STATE OF NORTH CAROLINA
DEPARTMENT OF TRANSPORTATION

Subject: **Modification Request for the Individual Section 404 and Section 10 Permits, Section 401 Water Quality Certification and CAMA Major Development Permit** for the Wilmington Bypass from north of US 74/76 in Brunswick County to US 421 in New Hanover County. Federal Aid Project Nos. NHF-0017 (96) and STM-0017 (97), Division 3, TIP No. R-2633B. Debit \$475 from WBS Element 34491.1.2

PERMIT DRAWING
SHEET 2 OF 73
REVISED: 1/20/2015

PERMIT DRAWING
SHEET 65 OF 73
REVISED: 1 / 20 / 2015

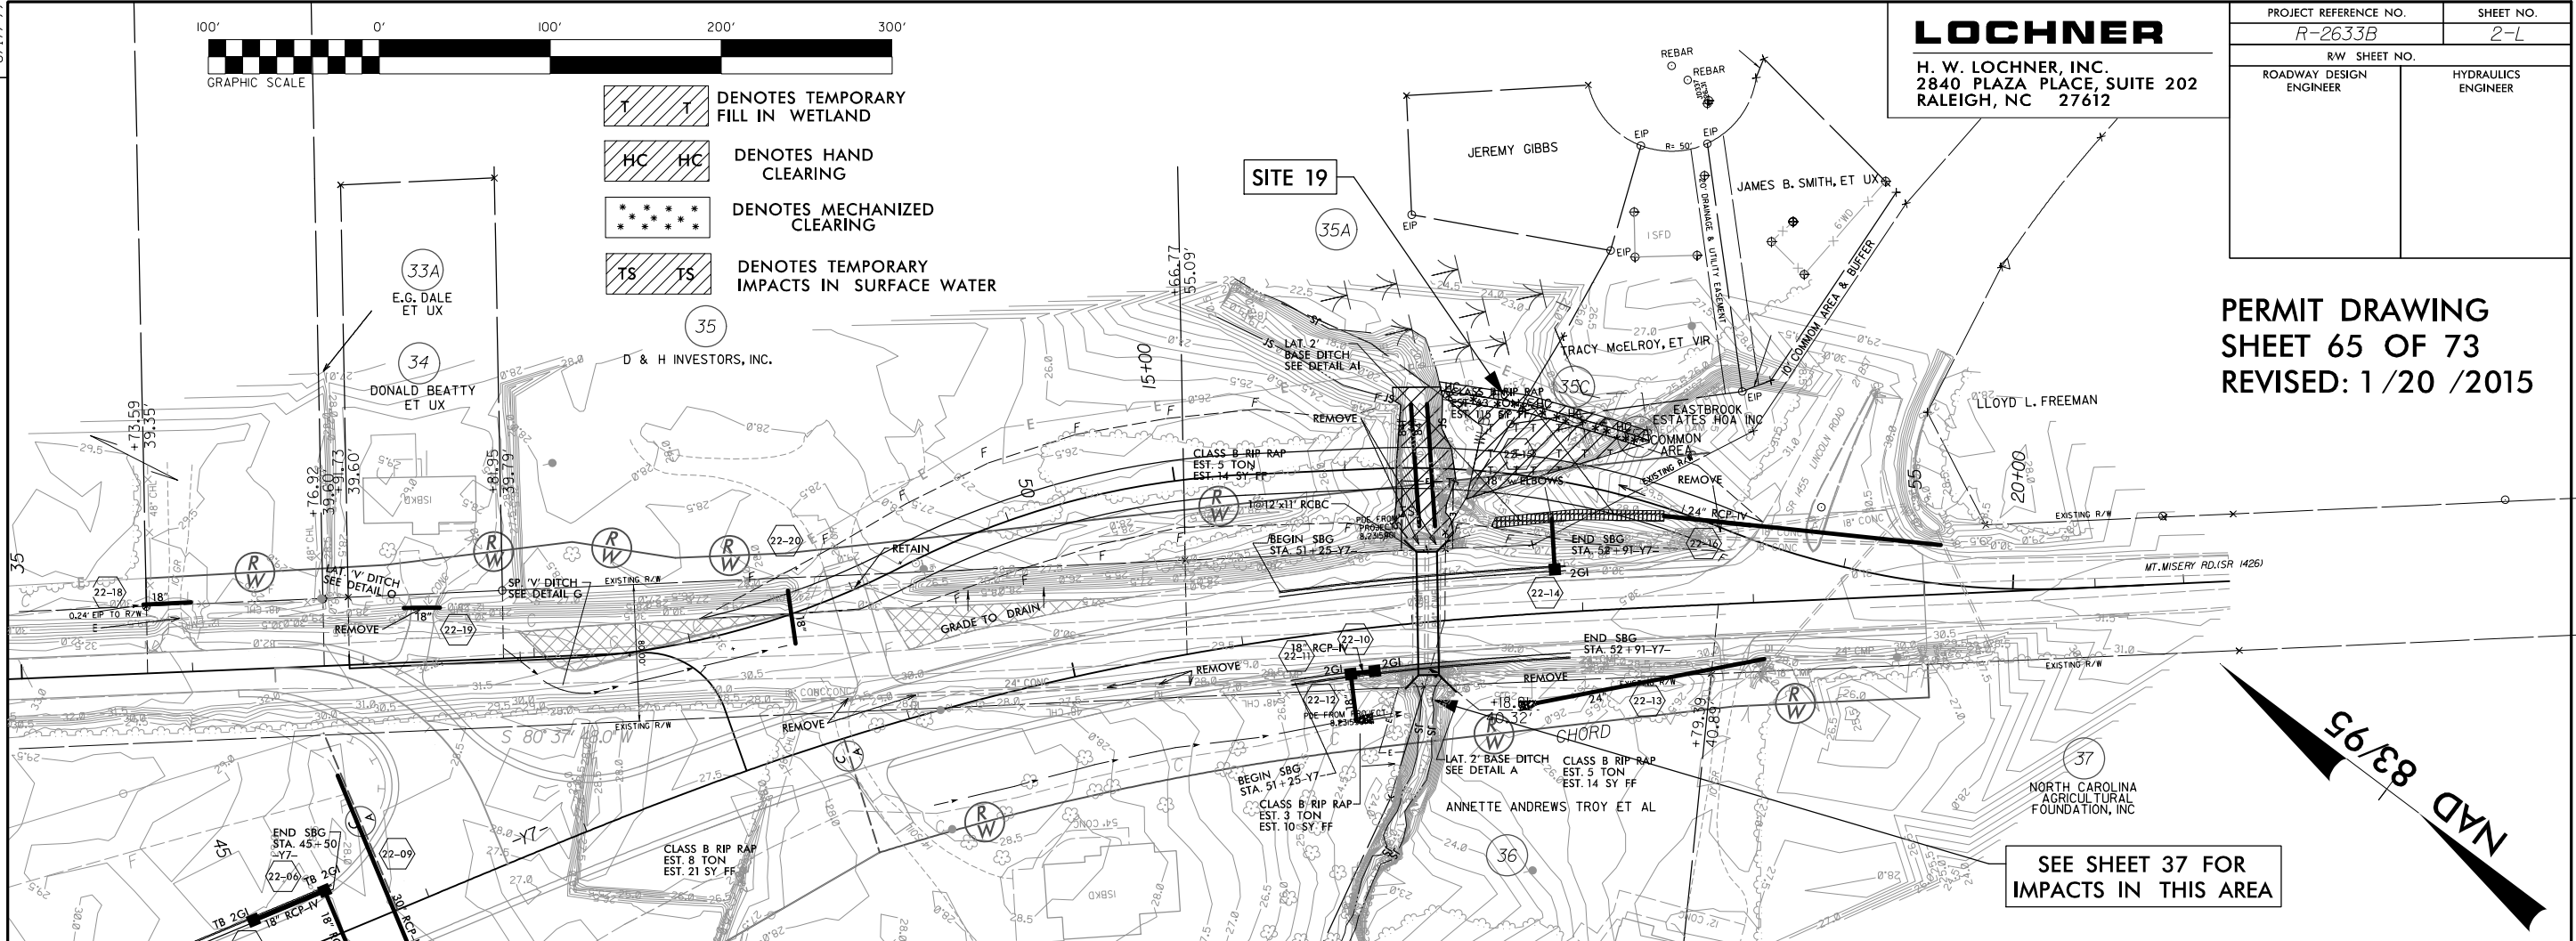
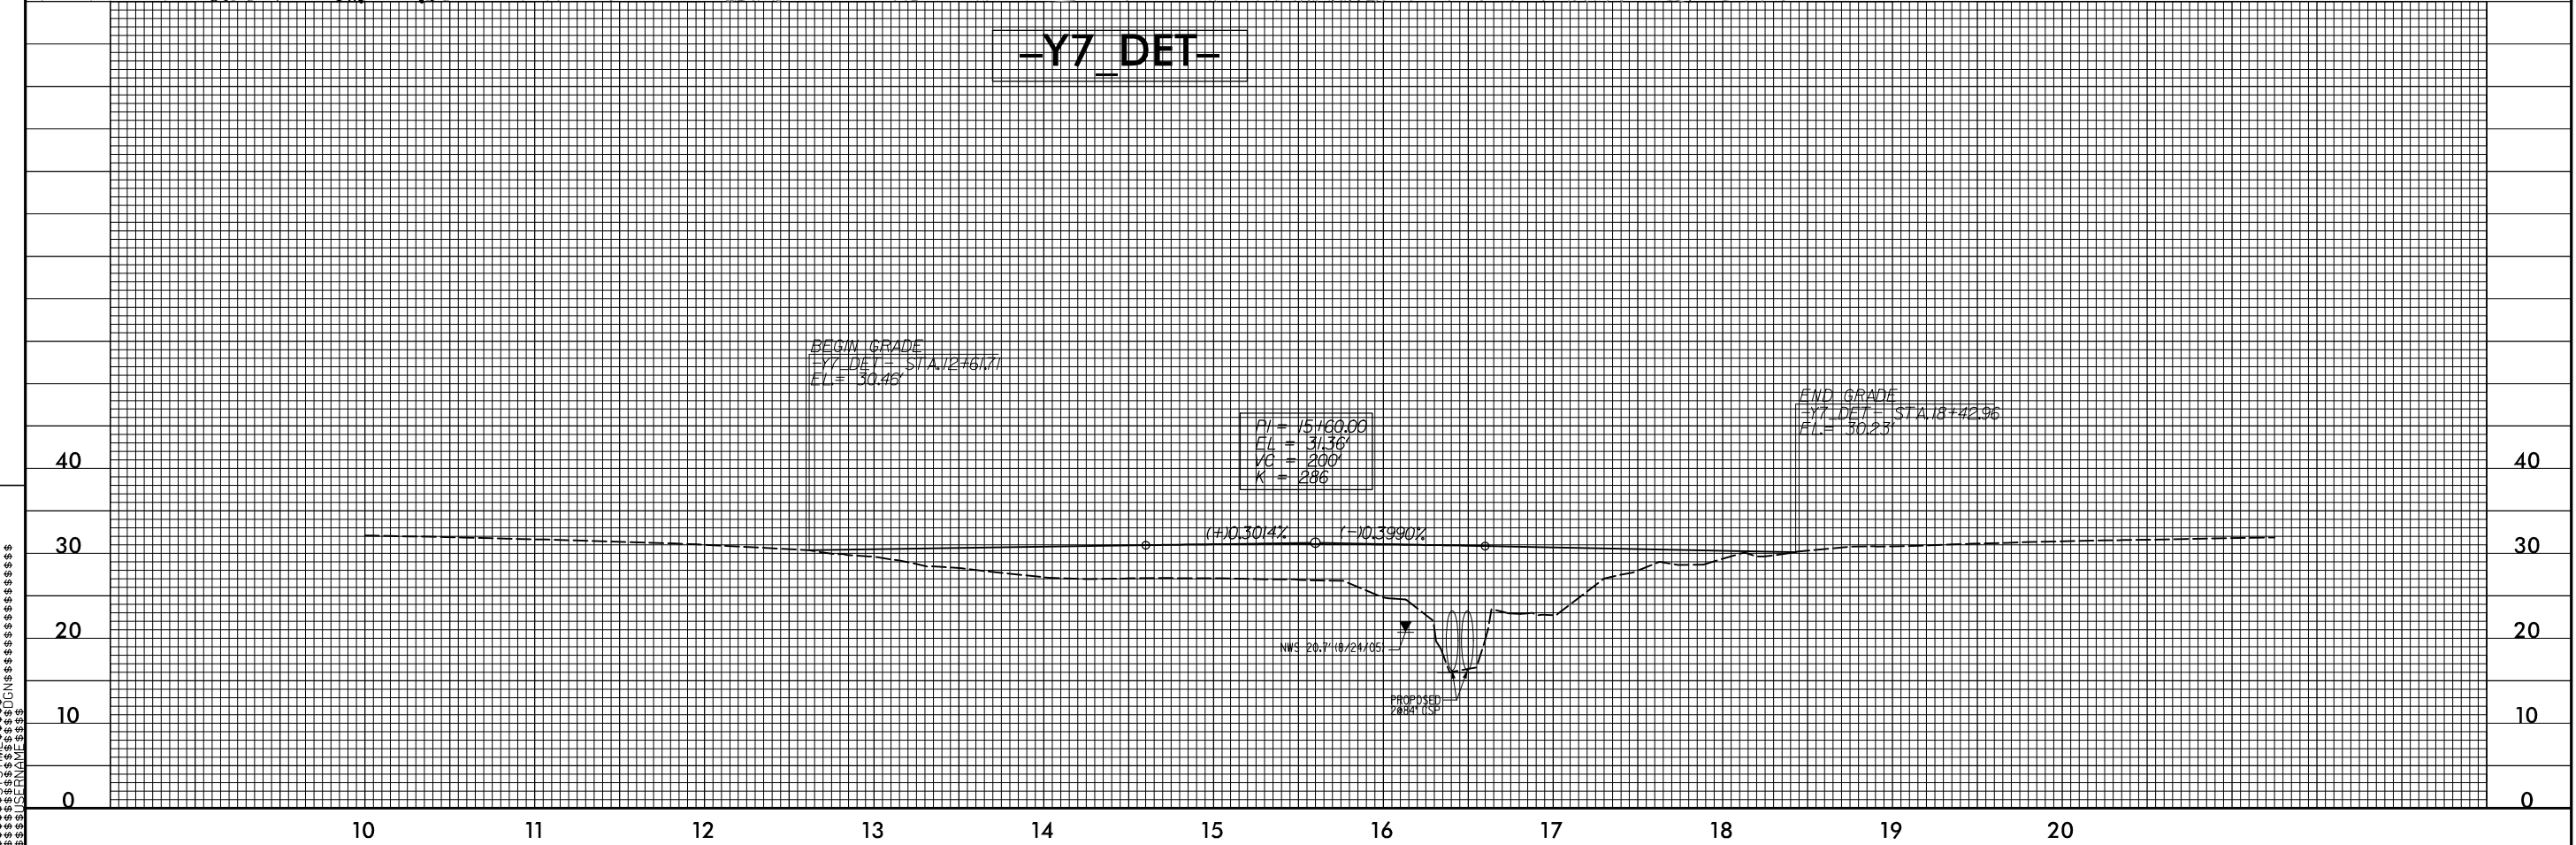
Site 19, detour drawing, Sheet 2L was revised from the original drawing. The original profile on this drawing showed the temporary pipes buried 3 feet. This was later questioned and the consultant collected more recent data. The drawing was changed but the temporary pipes on the profile now appear to be sitting on top of the streambed. See enclosed screen snapshot drawing showing the pipes will be buried one foot. Permit Drawing Sheets 64 and 65 of 73 have been revised and included in this application. No changes have been made to jurisdictional impacts.
